Highways Technical Note

Project: : 8-10 Moor Lane, South Shields, NE34 6BZ
Ref: ST/0140/24/FUL
Date: 18th July 2025

1.1.1 This technical note provides updating information to the highway authority South Tyneside Council (STC) for the above application dated 11th December 2024.

TRACKING PLAN

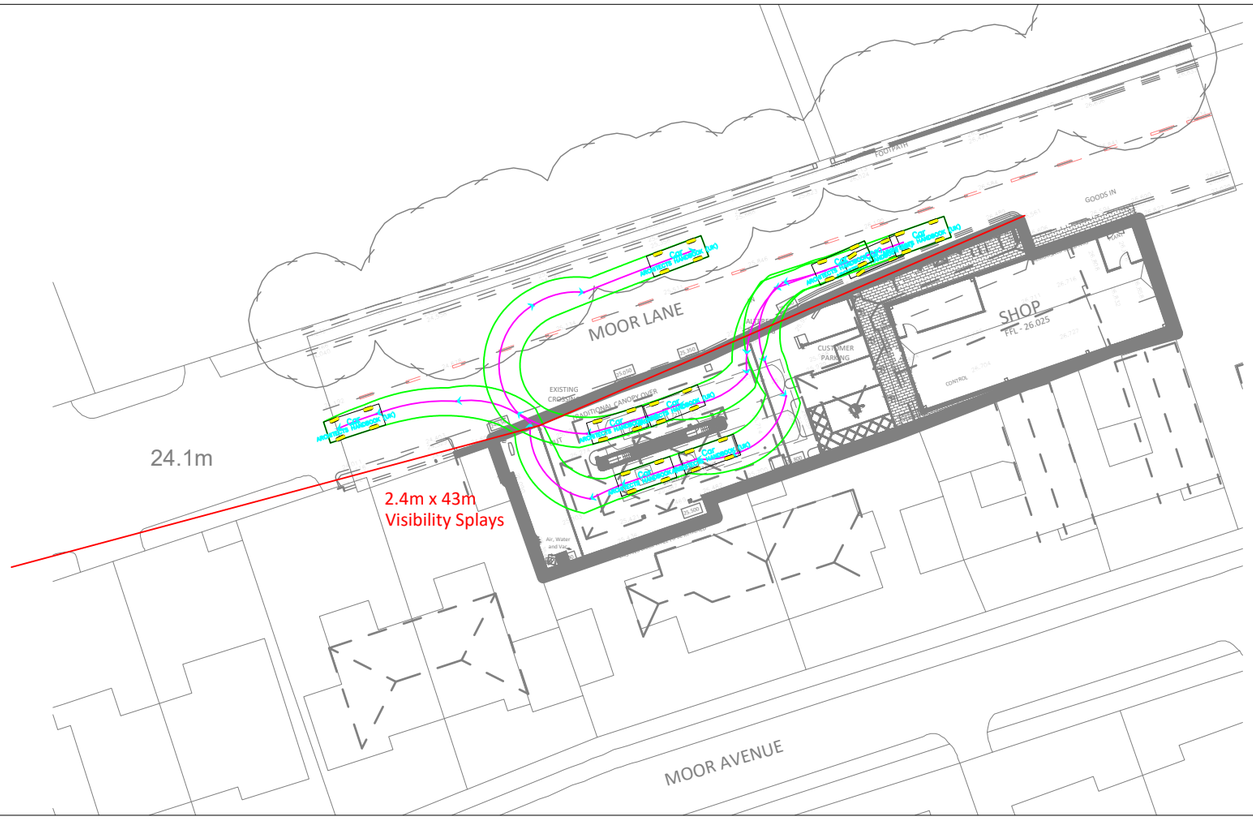
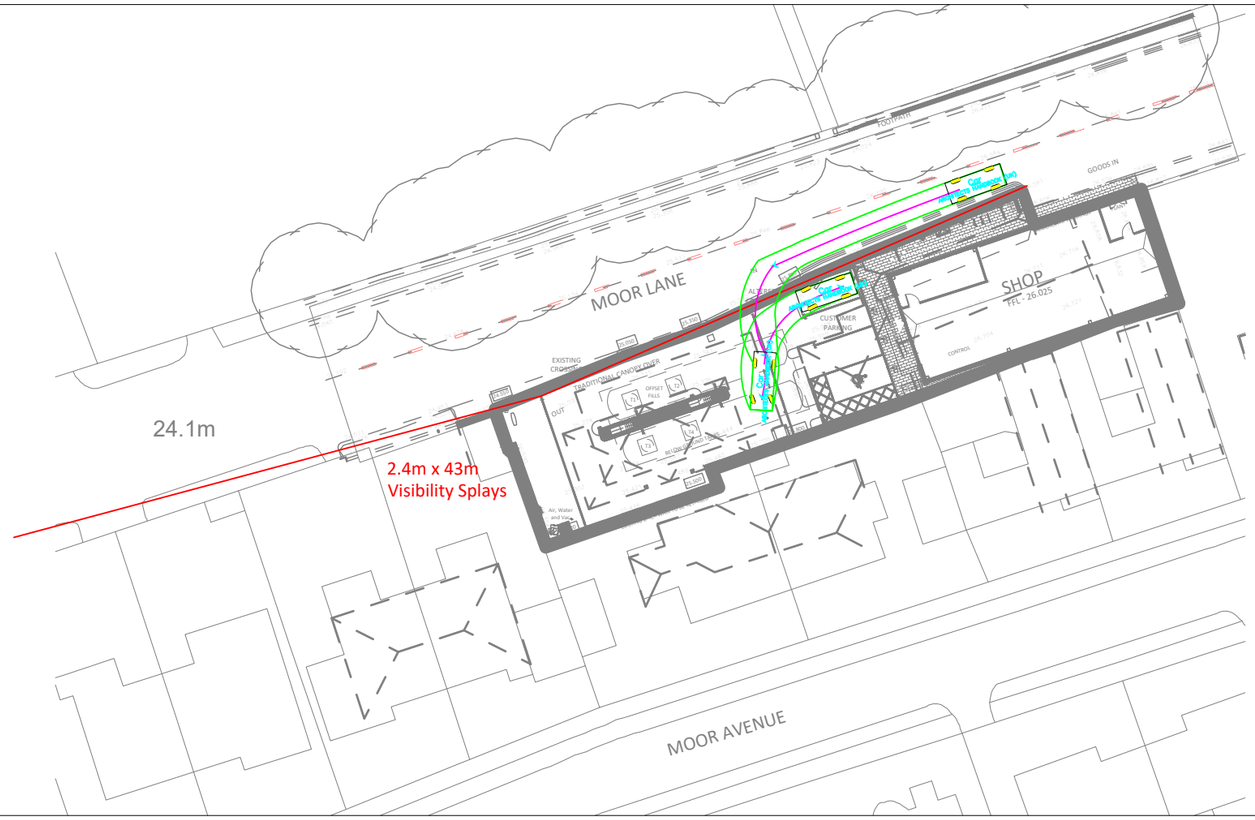
Notwithstanding the issues of highway land encroachment mentioned above, the proposed service area for goods is located to the north-east corner of the development site, accessed directly from the highway carriageway edge with no inter-visibility. In addition, no swept path of vehicles or details of service vehicles have been provided to show how the servicing arrangements could be satisfactorily and safely accommodated, including avoiding any reversing manoeuvres of service vehicles on the highway carriageway into the path of vehicles travelling along Moor Lane, particularly in close proximity of the Sunderland Road junction 28m further east.

The swept path/tracking of a service vehicle/tanker accessing and egressing the garage forecourt site is shown in the opposite direction of the general one-way vehicular flow proposed for the garage. Please provide tracking for the correct direction of vehicle flow, unless the current one-way system is to be retained due to concerns raised in point '3' above.

1.1.3 The development would be serviced by oil tankers and 10-12m HGVs. Tracking is shown in **Appendix B** for the worstcase assuming a 16.5m artic.
